ADDITIONAL ADDENDA TO THIRD REPORT OF TAAG - Hmb-581-82

TO: File FILE NO. TMI  
FOR: Information DATE July 16, 1982  
FROM: G. W. Tucker and C. M. Ball  
SUBJECT: Three Mile Island Unit No. 2 500-Ton Polar Crane - NNS Comments and Recommendations for Reactivation

**TO** E. J. Wagner  
**FROM** *R. Oakes / H. Young*  
 R. Oakes/H. Young  
**SUBJECT** W.O. 3680-01  
 Technical Assistance & Advisory Group  
 TMI-2 Recovery  
 Closure Head and Fuel Removal Containment

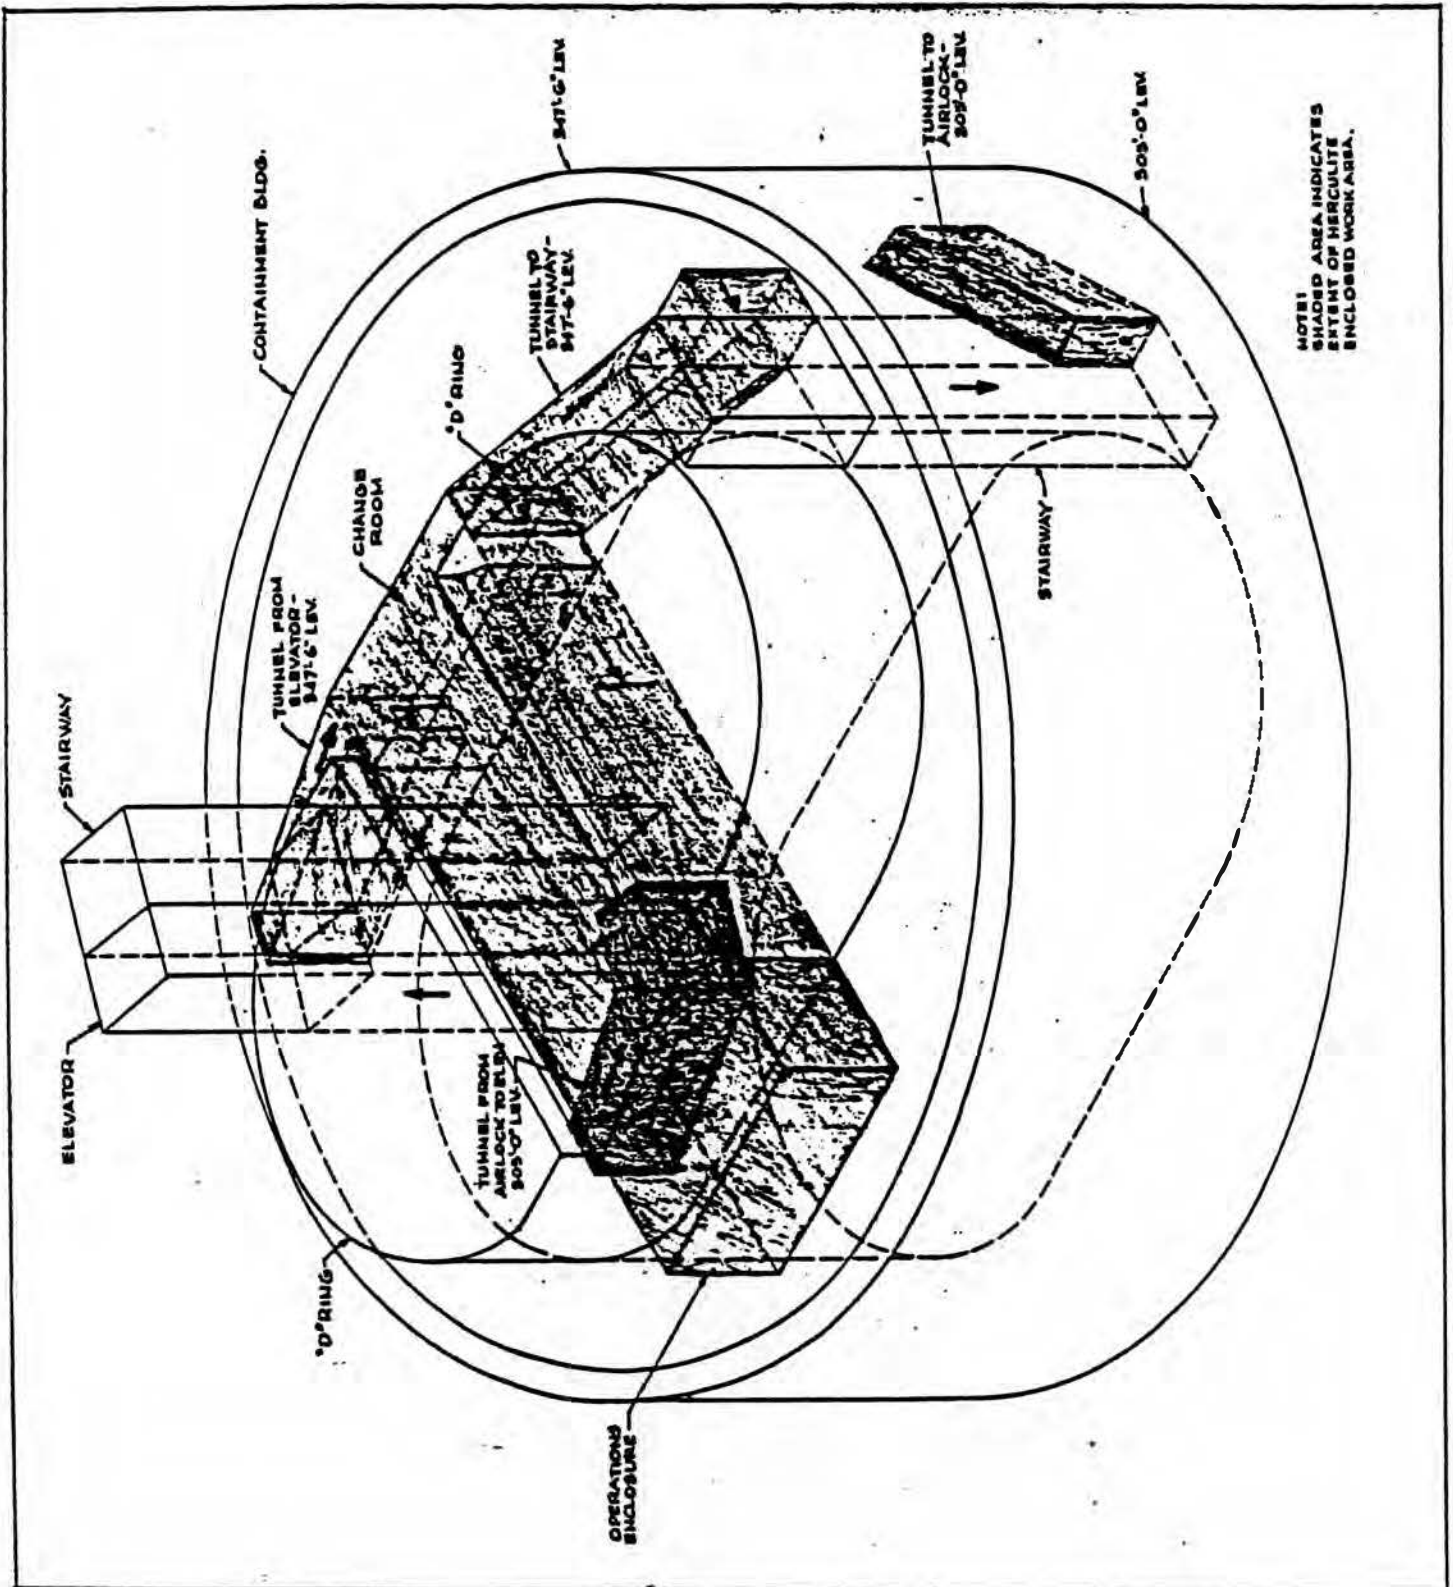
The layout of the tent on the 347'6" elevation on the Attachment (a) sketch has the following deficiencies: it routes personnel into areas of higher radiation, it places the change room on or near the covered hatch, and it does not show the open stairway being enclosed.

A better layout is proposed on Attachment (c) & (d). Radiation Zones are shown on these Attachments as are locations for temporary shielding. The proposed layout is a preliminary path and must be verified by a directinal radcon survey prior to finalization.

Estimated Dose Rates Inside Reactor Building Elevator Shaft

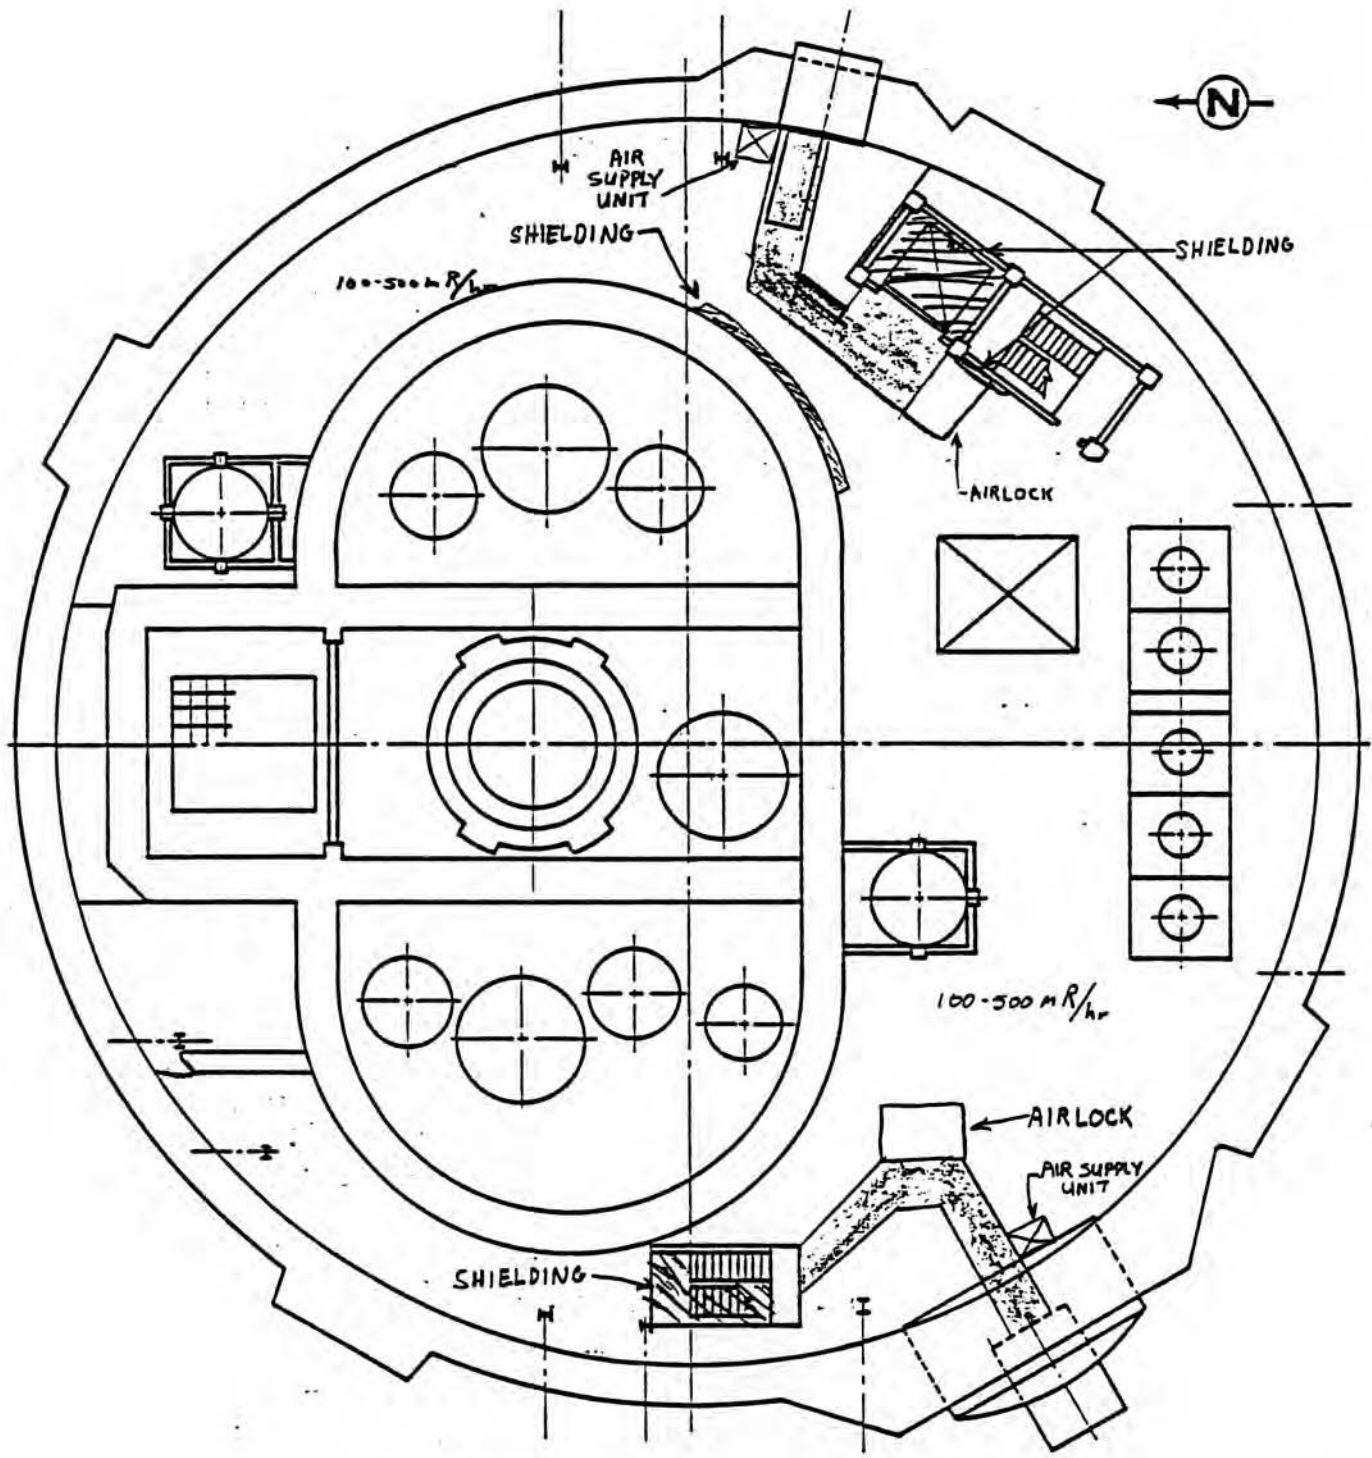
The tent installation shown in Attachment (a) sketch has personnel using the existing elevator to access El 347'6" from the El 305' personnel airlock. The use of the elevator is desirable because of the reduction of worker fatigue levels. However, the high radiation levels ( $\sim 16\text{R/hr}$ ) in the elevator shaft at elevation 305' requires the placement of temporary shielding in the shaft to permit the use of the elevator. It would take approximately 1.5" of lead to reduce the dose rates to ambient reactor building levels ( $\sim 100\text{ mR/hr.}$ ). However, covering the elevator truck's floor with 1.5" of lead will nearly equal the maximum load capacity of the elevator (5680# vs 6000# per Ref. 3). If the lead thickness is reduced to 1" in order to leave 2000# of load capacity, the dose rate at the elevation 305' position will be 1.3 R/hr and will decrease with elevation as shown on attachment (b). These dose rates are too high.

Therefore, shielding must be inserted into the elevator shaft to reduce the dose rates. The elevator shaft is a 2 hour fire rated structure so it has no exposed structural steel to facilitate supporting shield material. The shielding will have to be supported on structural beams inserted through the open doors and through the block wall at the back of the elevator shaft. Metal decking will be laid over the beams and 2" of lead will be placed on the decking. Modifications to the elevator controls will be necessary to prevent damage to the shield.

CONCEPTUAL SHIELDING DESIGN FOR ELEVATOR

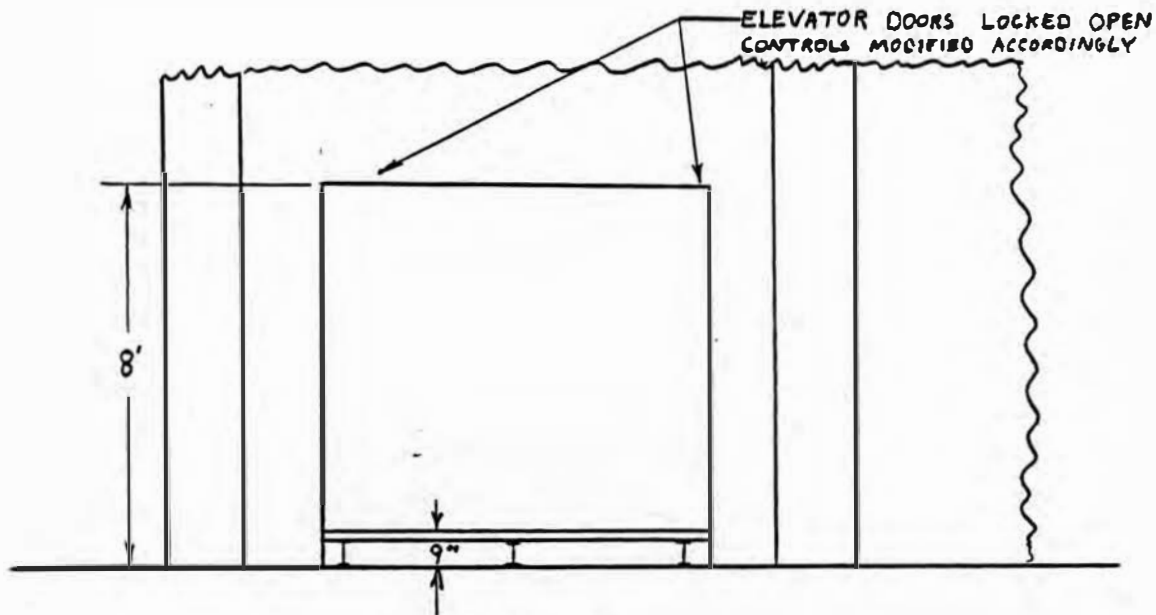
The shielding of the elevator shaft must be accomplished in order to utilize the elevator as described in Section 3. A method of supporting two inches of lead in the shaft must be developed. A conceptual design for such an arrangement is shown in Attachment (e). If required, the structural steel can be cut in pieces to facilitate handling. The I beams are ten feet long and can be carried into the containment building through the personnel airlock.
